Bid Addendum

Bid Title : PO Hoffer Water Treatment Facility and Glennville Lake Water Treatment Facility Reliability Improvements Contract No. 55

Addendum Number: 3

ADDENDUM NO. 3 – TECHNICAL SPECIFICATIONS AND DRAWINGS

Attachment #6 – Sheet C303 Figure

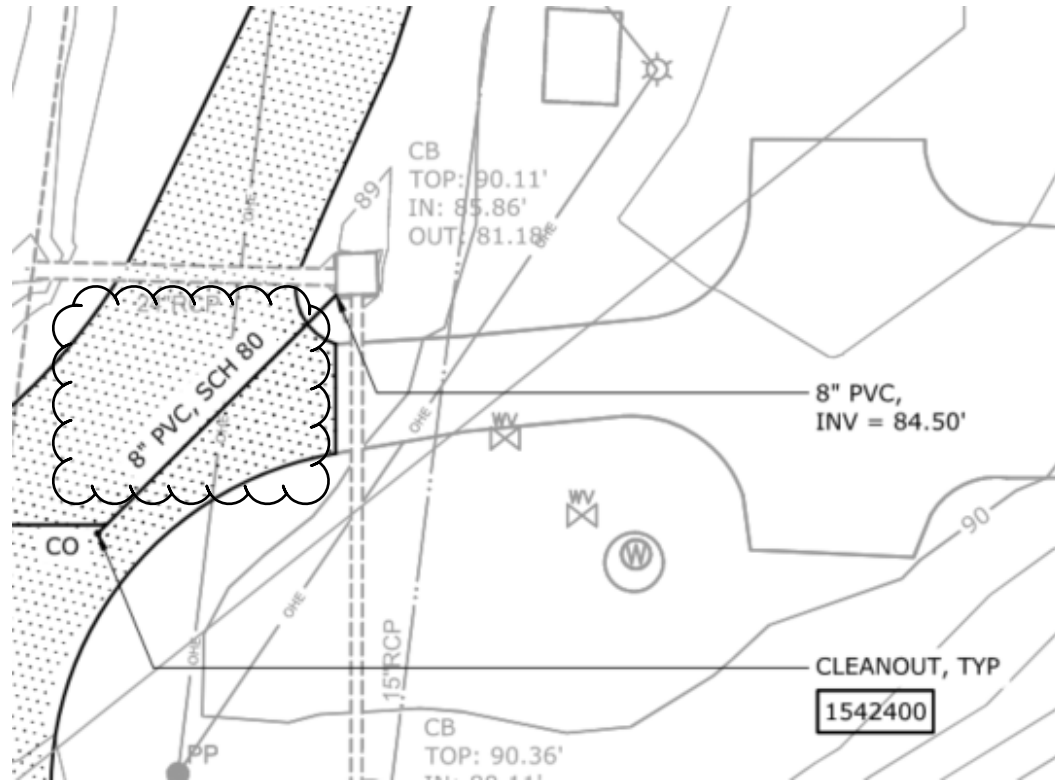
1. Revised PVC callouts on sheet C303 to include “SCH 80”, see **Attachment #6**.

Attachment #7 – Sheet E903 Figure

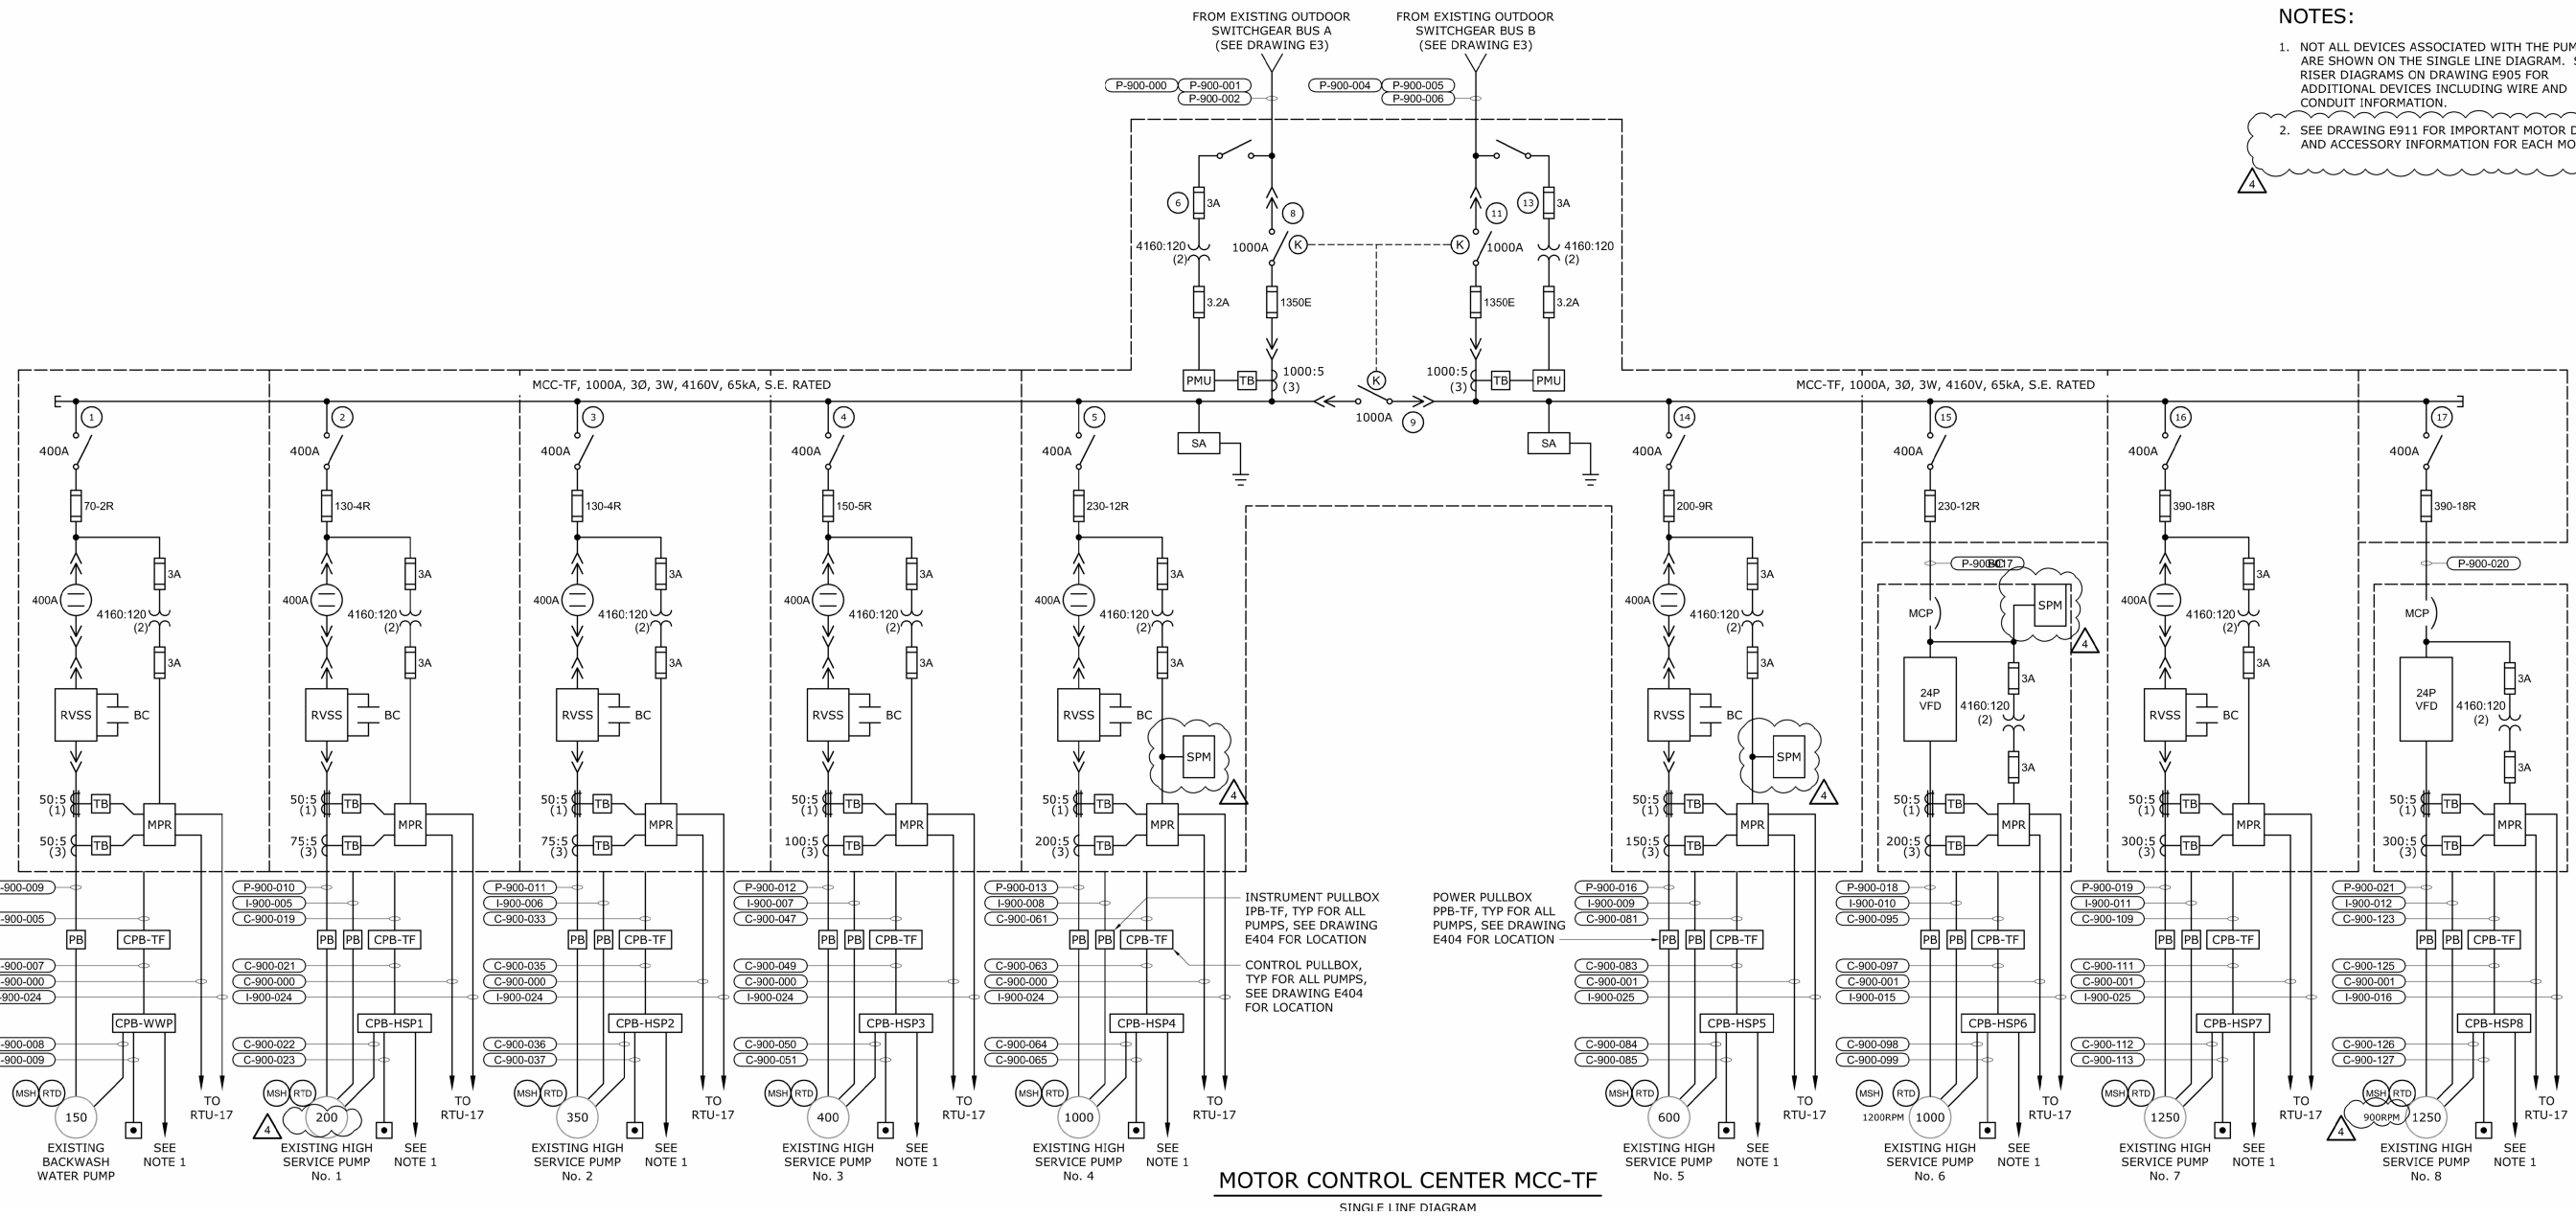
1. Modify the single line diagram as shown in **Attachment #7**.

Attachment #8 – Sheet E906 Figure

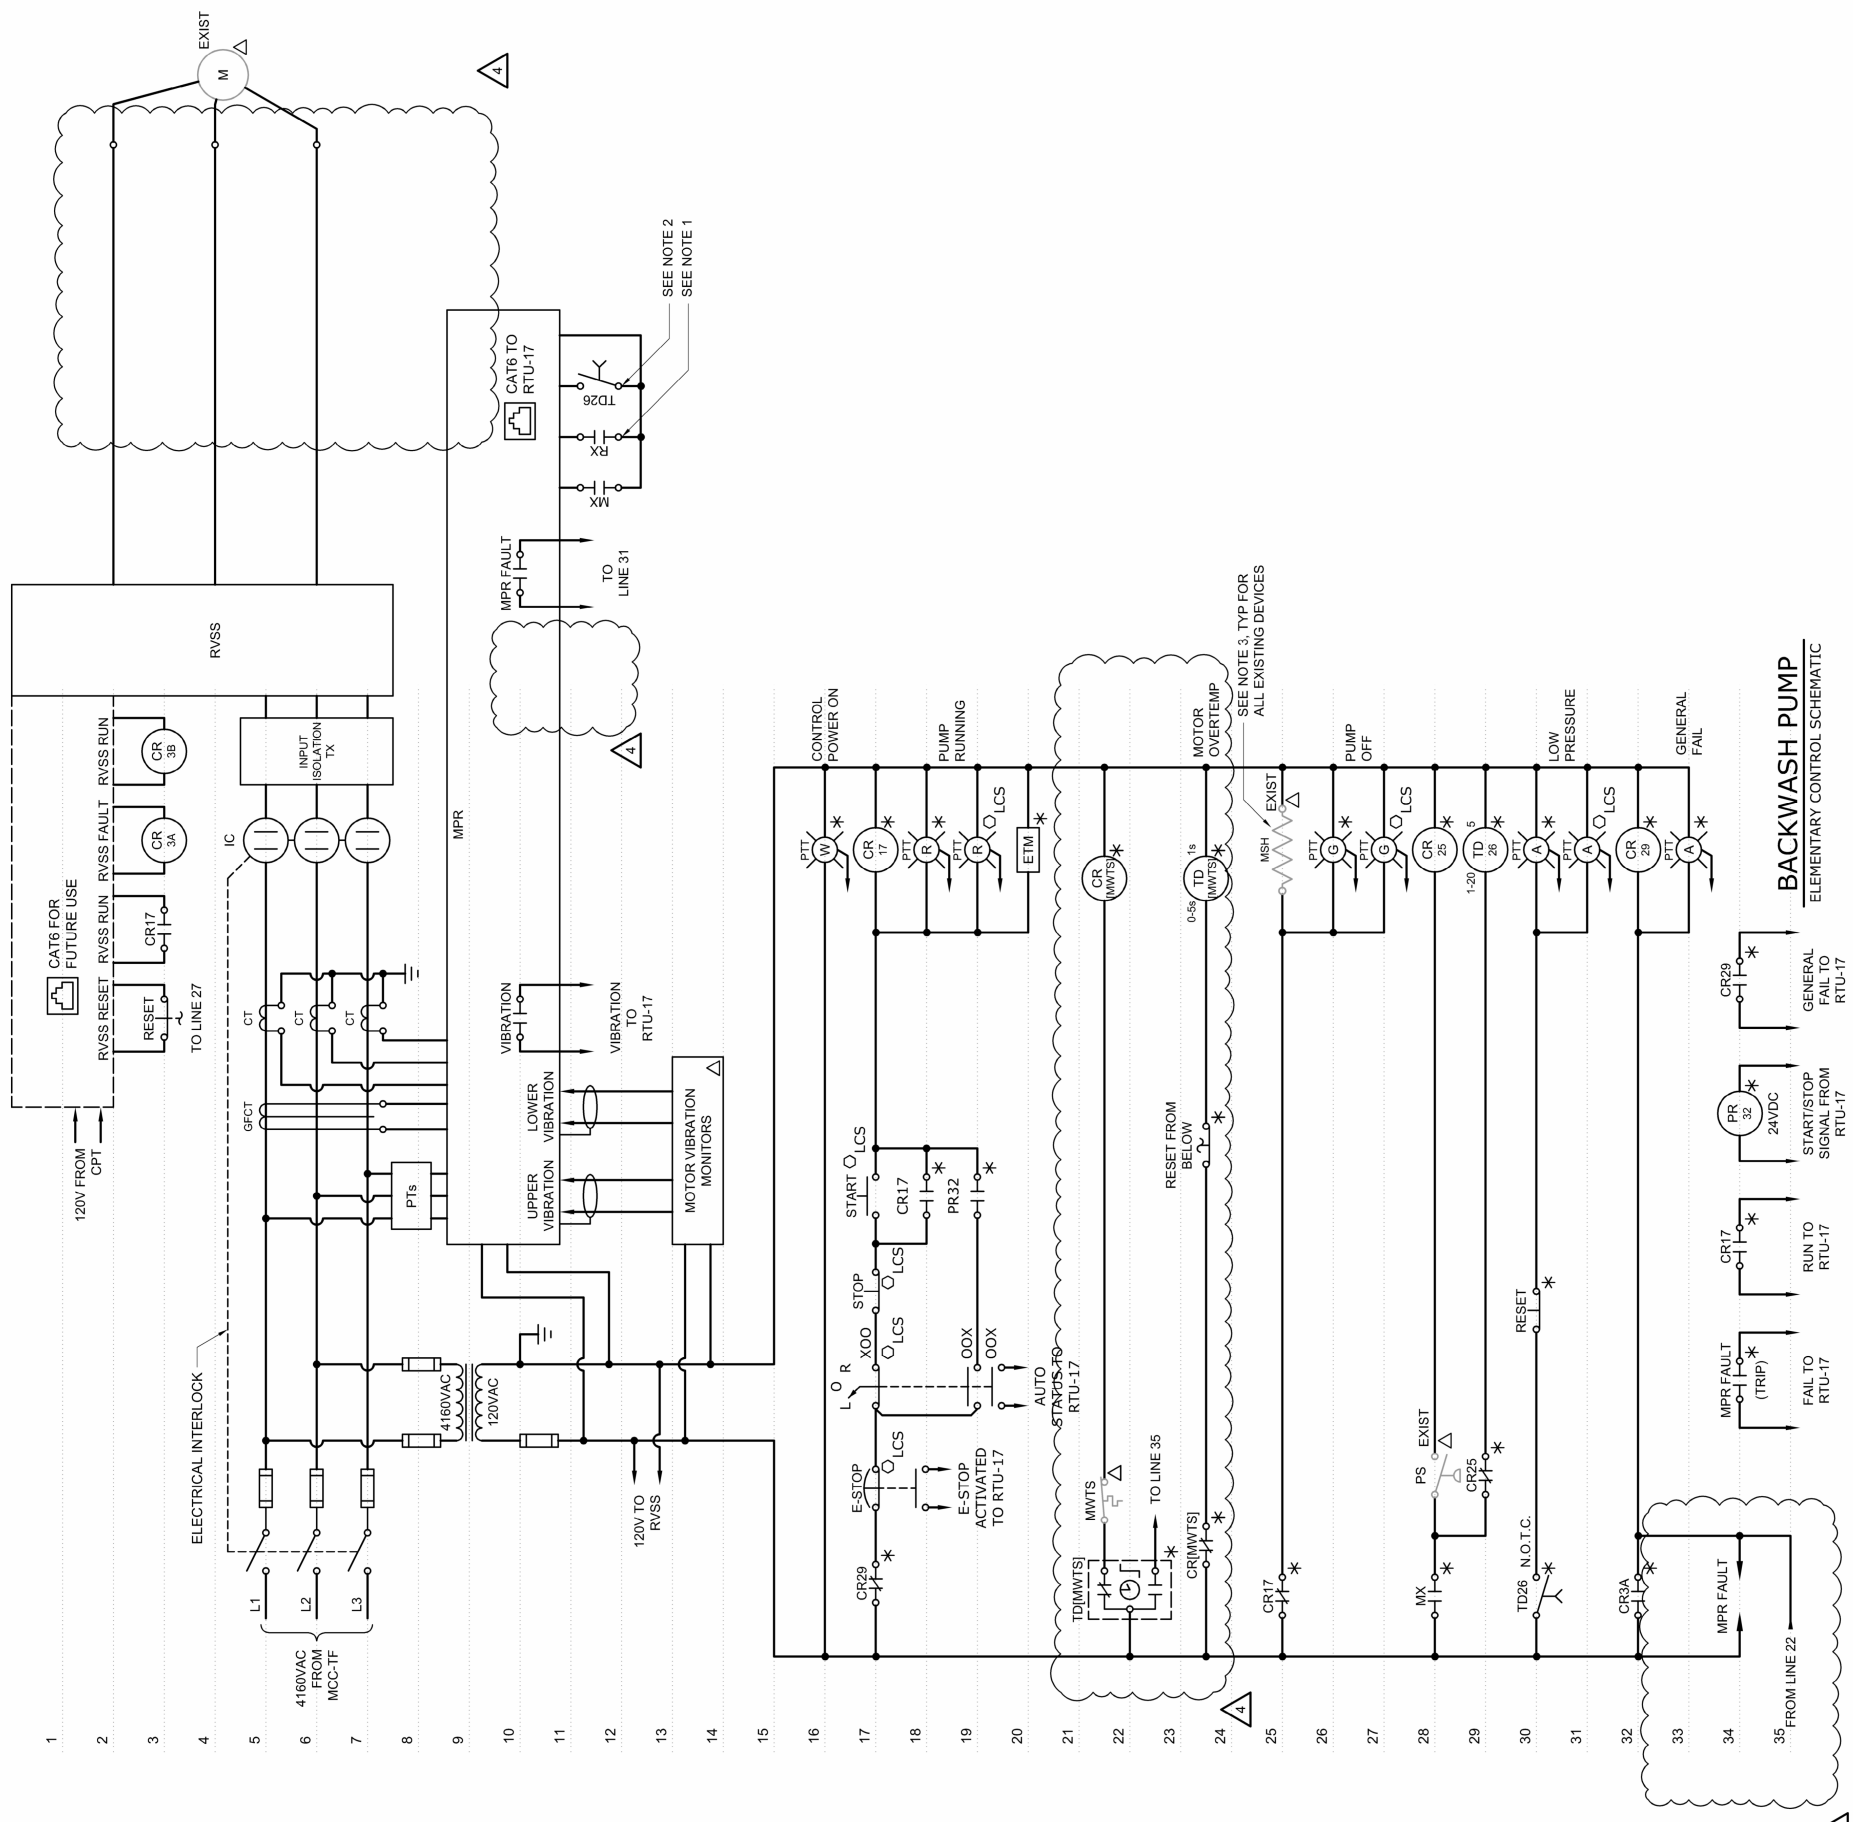
1. Modify control schematic as shown in **Attachment #8**.

Attachment #9 – Sheet E907 Figure

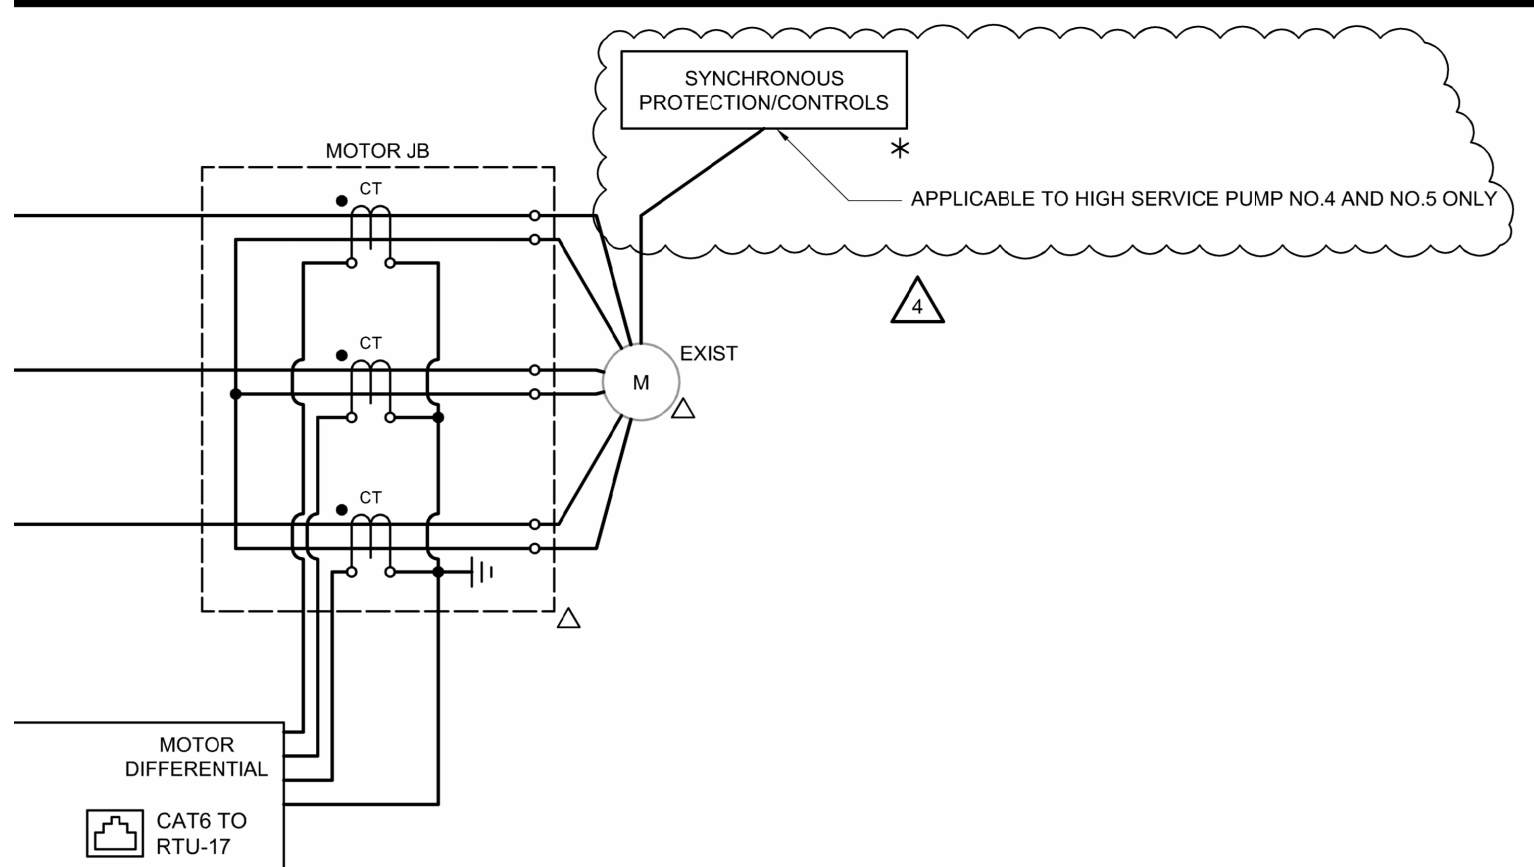
1. Modify control schematic as shown in **Attachment #9**.

Attachment #10 – Sheet E908 Figure

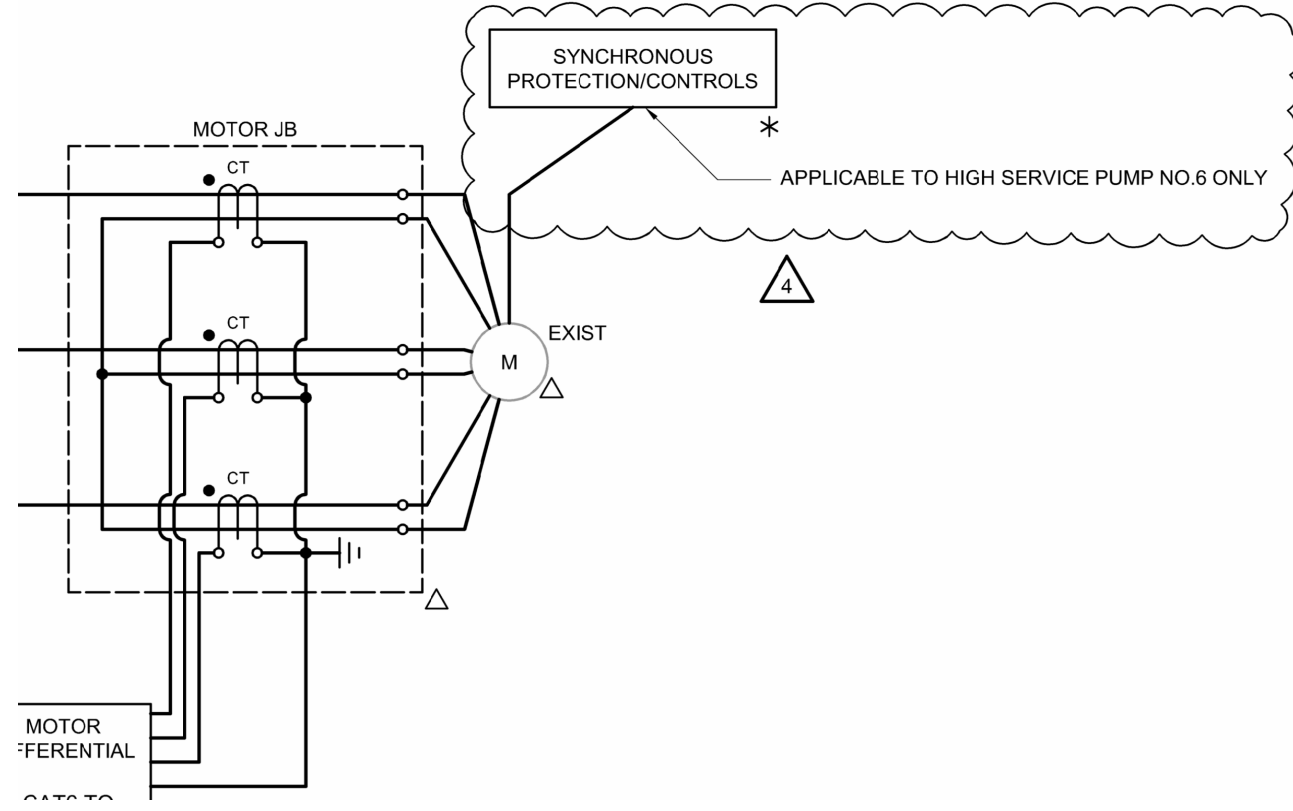
1. Modify control schematic as shown in **Attachment #10**.
